**PLANNING COMMISSION AGENDA**  
**City Commission Chambers - City Hall**  
625 Center Street, Oregon City, Oregon 97045  
**November 8, 2010 at 7:00 p.m.**

TO:	Planning Commission
FROM:	Tony Konkol, Community Development Director
PRESENTER:	Pete Walter, Planner
SUBJECT:	Master Development Plan for the redevelopment of the Hilltop Mall. Planning Files CP 10-01, DP 10-02 and WR 10-03.
Agenda Heading: Public Hearing	
Approved by: Tony Konkol, Community Development Director

**QUASI-JUDICIAL LAND USE DECISION (TYPE III)**  
**Staff Report and Recommendation to the Planning Commission**

**FILE NO.:** CP 10-01: Concept (General) Development Plan<sup>1</sup>  
DP 10-02: Detailed Development Plan (Site Plan and Design Review)  
WR 10-03: Natural Resource Overlay District (NROD) Review

**WEST ELEVATION - B**  
DATUM ELEVATION = 100'-0"  
(RIGHT)

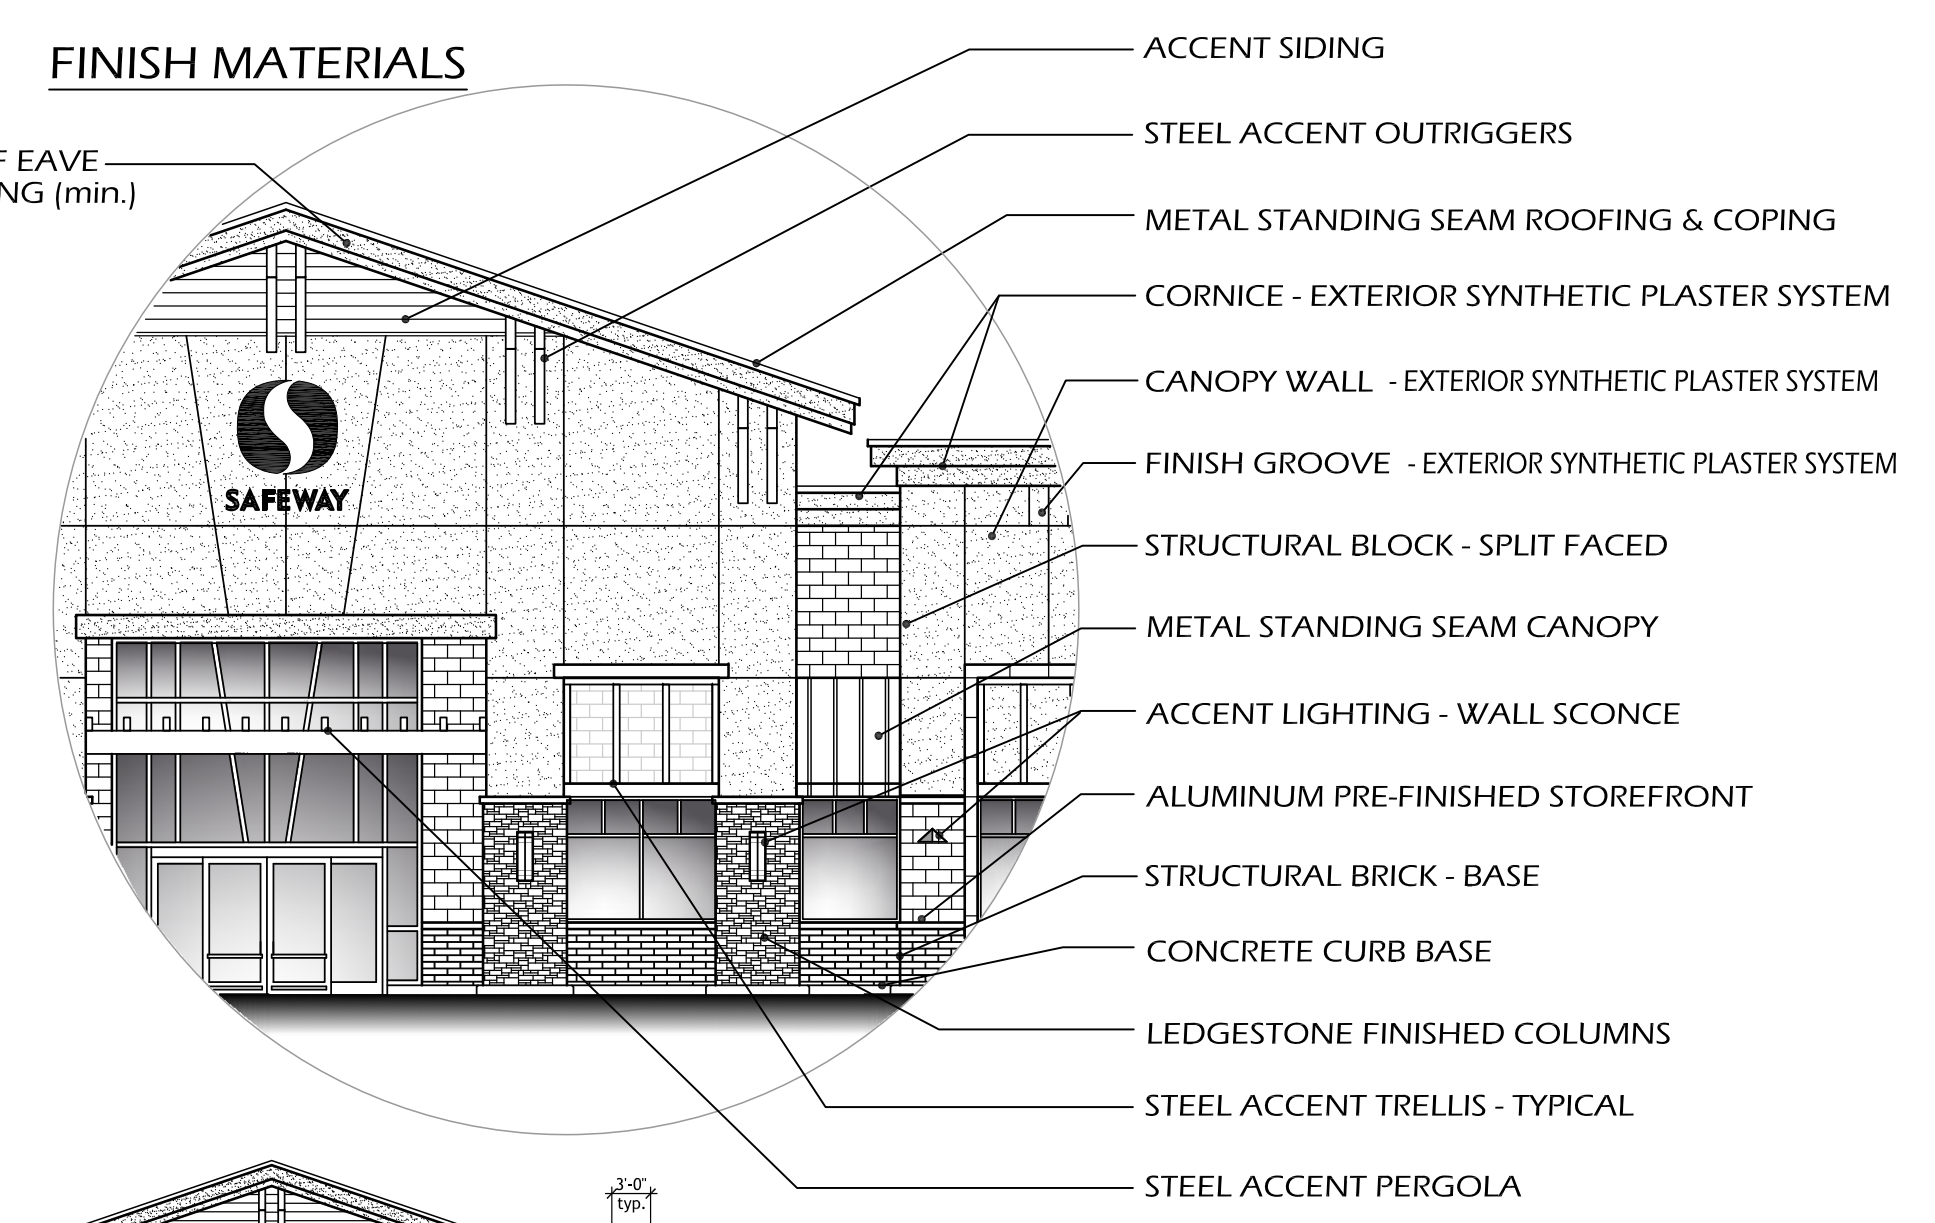
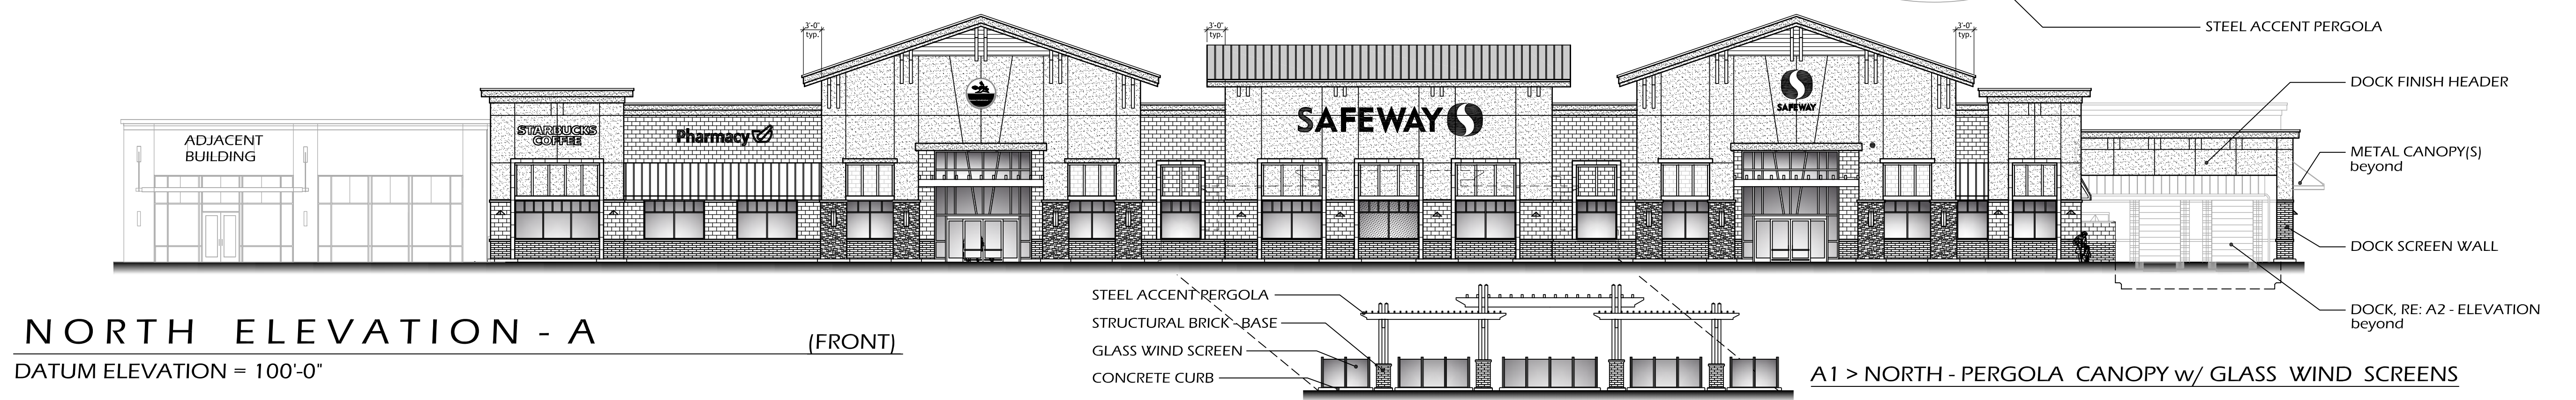
Further in Staffs Text on page 60 staff reviews the Safeway Gables and Eaves which were not shown as being the full 3' per criteria b.

*Regarding overhanging eaves, the gabled roof elements are shown project between 1' to 2.5' beyond the roof canopy, therefore standard (b) of this section has not been met.*

The elevations are in compliance under the other criteria but Safeway is proposing that the major overhangs will comply with the 3' eave length. Please see KJD2 Elevation 2.2 that highlights the eaves that comply with the 3' criteria.
